Continuously Variable Valve Timing –
CVVT Unit Retaining Bolt –
Revised Torque Not In JTIS

MODEL
1999 MY-ON XK8 Range
1999 MY-ON
VIN V8 XJ Series NA
031303-ON
853936-ON

ILLUSTRATION 1

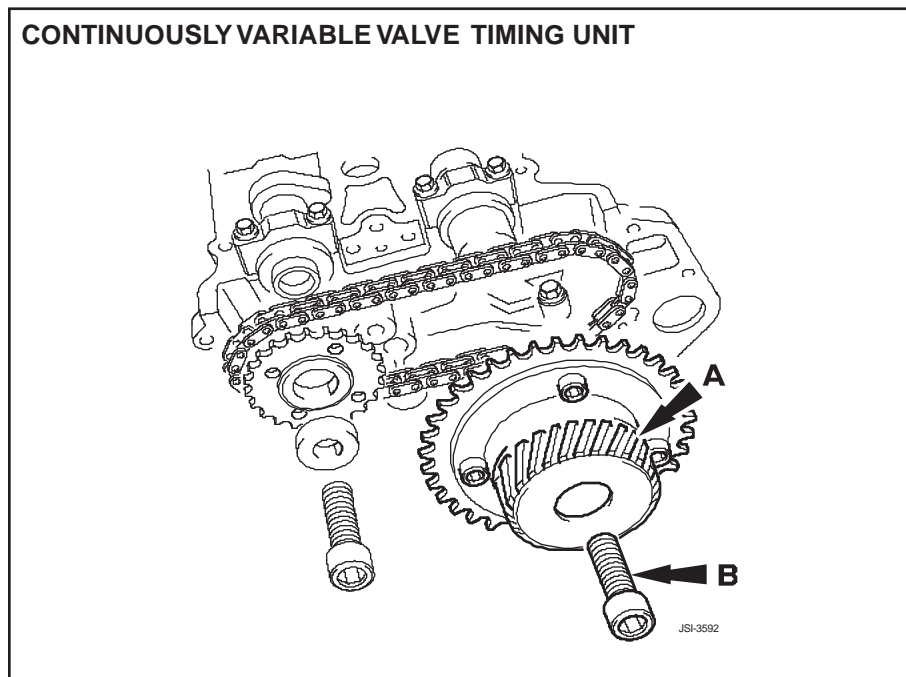
The introduction of Continuously Variable Valve Timing, (CVVT), on 1999 Model Year AJ27 (normally aspirated) engines has required a change of timing unit from the one used on AJ26 engines. The CVVT unit can be identified by the helical splines, (A, Illustration 1), on the unit body.

The retaining bolt for the CVVT unit, (B, Illustration 1), has an oil passage drilled through the center and requires a lower torque specification when the unit is assembled to the camshaft.

Note: The torque specification of **115 - 125 Nm** specified in JTIS section **303-01**, which is applied to the VVT retaining bolt on AJ26 engines, **must not be applied** to the CVVT retaining bolt on AJ27 engines.

Note: When assembling the CVVT unit on the camshaft, the retaining bolt must be first tightened **30-40 Nm**: and then to **85-90 Nm**.
